PRODUCT BULLETIN

EFFECTIVE FEBRUARY 2022

PRODUCT CHANGE NOTICE – AEROFLAP® MUD FLAPS

FIGURE 1

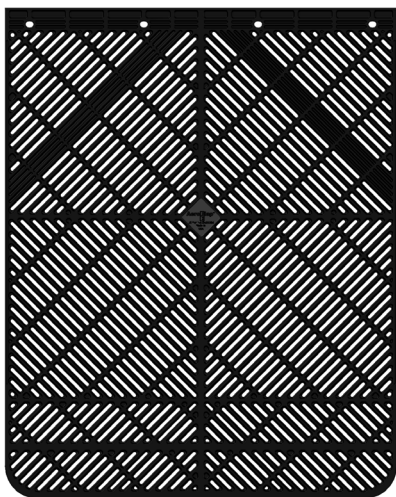
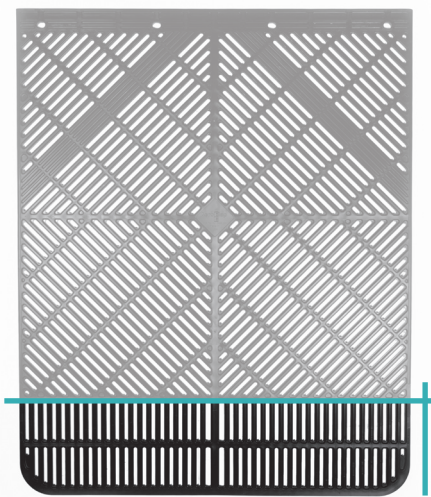
The Engineers at Tramec Sloan have redesigned the bottom of our longer **AEROFLAP MUD FLAPS** to feature angled slats rather than vertical slats. Details shown in Figure 1.

This design change affects **AEROFLAP MUD FLAPS** with vertical slats at the lower extremity, and applies specifically to those vertical slats. See part numbers listed below.

NEW DESIGN
with Angled Slats at the Bottom

ORIGINAL DESIGN
with Vertical Slats at the Bottom
